Access Compliance Report

Public Rights-of-Way

(Curb Ramps)

Intersection ID: 31672	Main Street: EAVES_LN	Cross Street: PLAZA_WALK_DR	Location: NW
ADA ID: 47B79CFD4101	Ramp Type: Combination1Diag	Initial Pass/Fail: Fail	Overall Compliance: No
		Severity Score: 0

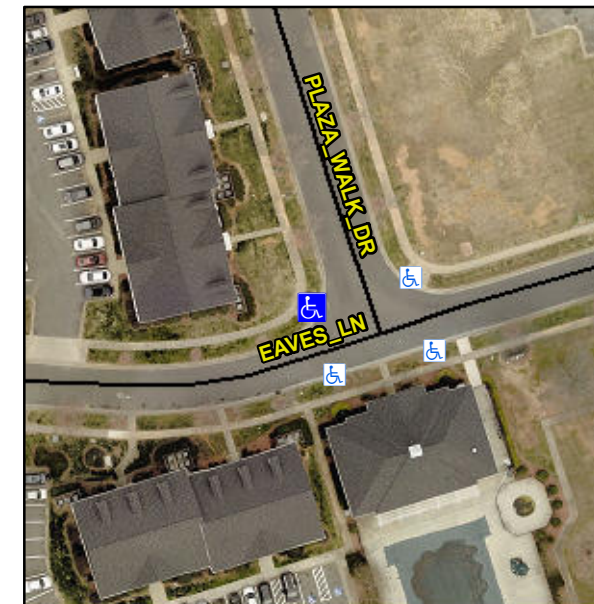
RT RP < 5%

Not Found, R304.5.1, R304.5.3, R304.3.2

Remove & Replace Curb Ramp With Two New Directional Ramps or Equivalent.
